Addendum 128 – UN Regulation No. 129

Revision 4 - Amendment 2

Supplement 2 to the 03 series of amendments – Date of entry into force: 11 January 2020

Uniform provisions concerning the approval of Enhanced Child Restraint Systems used on board of motor vehicles

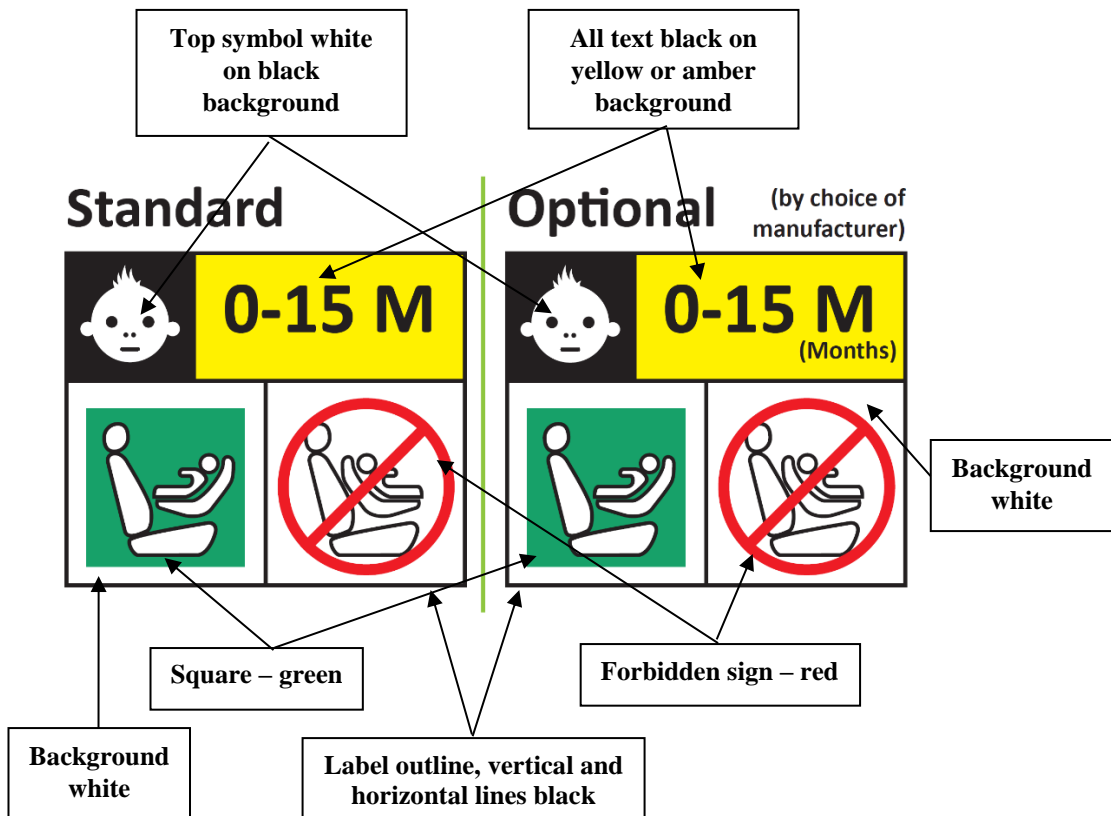
Paragraph 4.5., amend to read:

"4.5. Integral Enhanced Child Restraint Systems that can be used forward and rearward facing, shall have the following label permanently attached on the part hosting the child and visible to the person installing an Enhanced Child Restraint System in the vehicle:

The manufacturer shall be permitted to include the word "months" to explain the symbol "M" in the label. The word "months" should be in a language commonly spoken in the country or countries where the product is sold. More than one language is allowed.

Minimum label size 40 x 40 mm

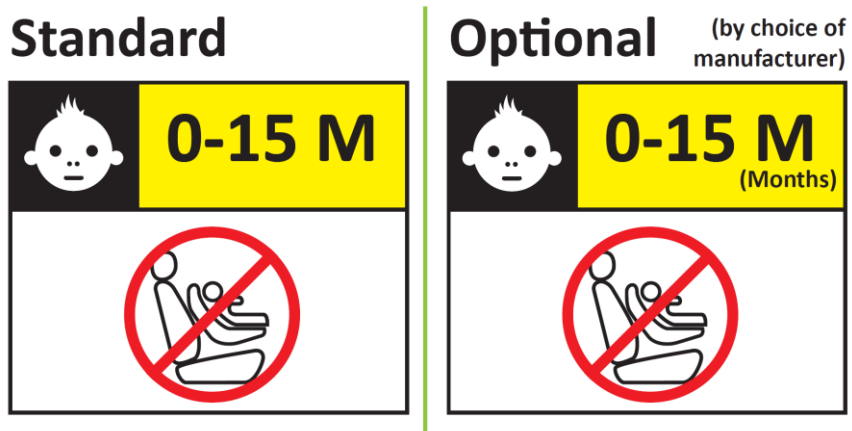
Integral Enhanced Child Restraint Systems that can be used forward facing only shall have the following label permanently attached on the part hosting the child and visible to the person installing an Enhanced Child Restraint System in the vehicle:

The manufacturer shall be permitted to include the word "months" to explain the symbol "M" in the label. The word "months" should be in a language

commonly spoken in the country or countries where the product is sold. More than one language is allowed.

Minimum label size 40 x 40 mm

Figure 1

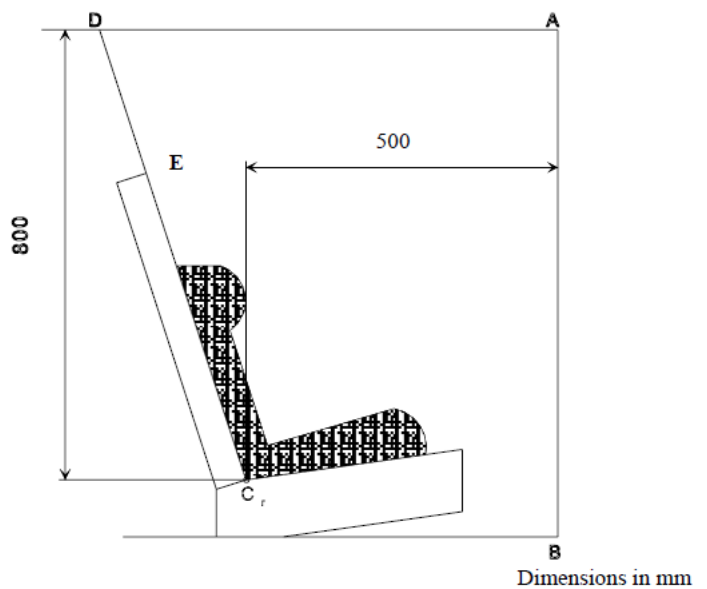
Paragraphs 6.6.4.4.1.1. and 6.6.4.4.1.1.1., amend to read:

Head excursion: No part of the head of the dummy shall pass beyond the planes BA, DA and DE as defined in Figure 1 below. However, the head of the dummy may pass beyond the DE plane, if there is part of the child restraint structure, i.e. head pad or backrest, behind the head of the dummy, at the point the head passes the DE plane.

Except for booster seats when testing using Q10 dummy where:

- (a) The value in relation to the DA plane is 840 mm; and
- (b) The value in relation to the BA plane is 550 mm; and

- (c) The rebound phase is not considered for the assessment of the plane DA and DE.

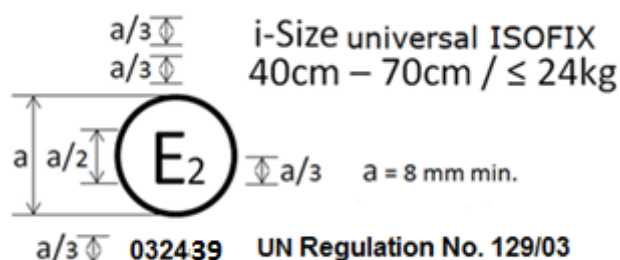
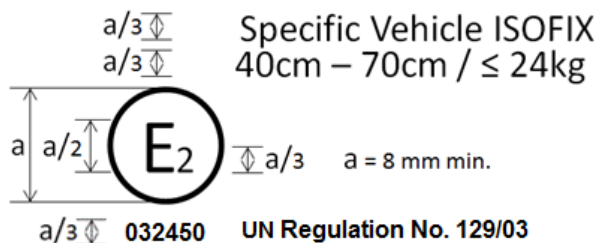
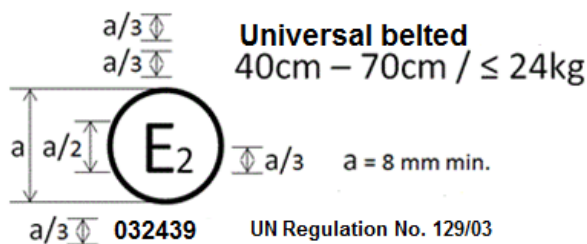
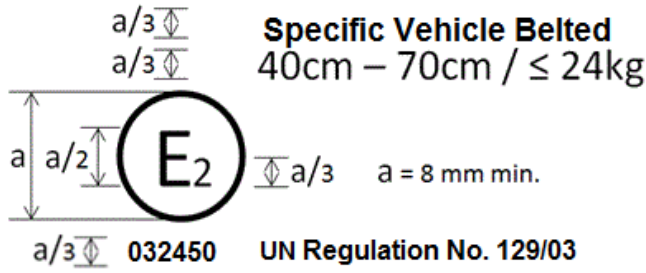
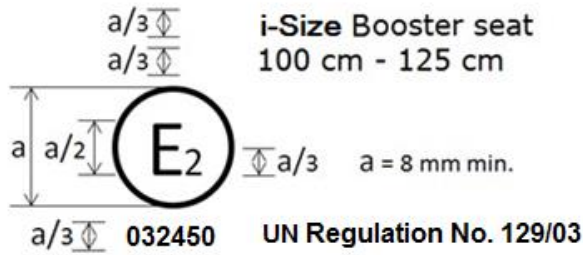
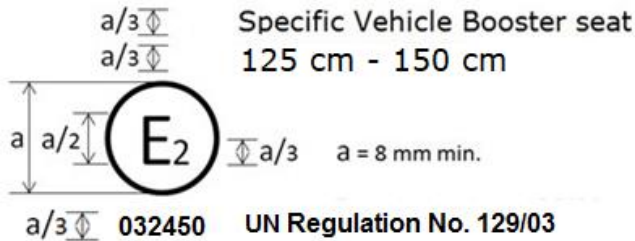
Annex 2., the example of approval markings only, amend to read:

The Enhanced Child Restraint System bearing the above approval mark...
 125 cm - 150 cm size range...

2. Arrangements of the approval mark in combination with a module mark

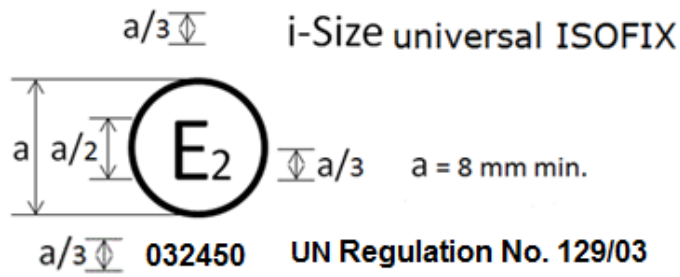
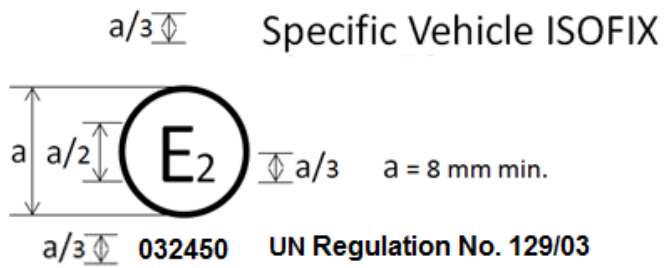
In case of combinations, for example an Enhanced Child Restraint System, that is approved as an i-Size Booster seat from 100 cm–125 cm and from 125 cm–150 cm as a Specific Vehicle Booster seat, the approval mark is to be combined as given below.

Combinations can only be made for those allowed by paragraph 3.2.2.
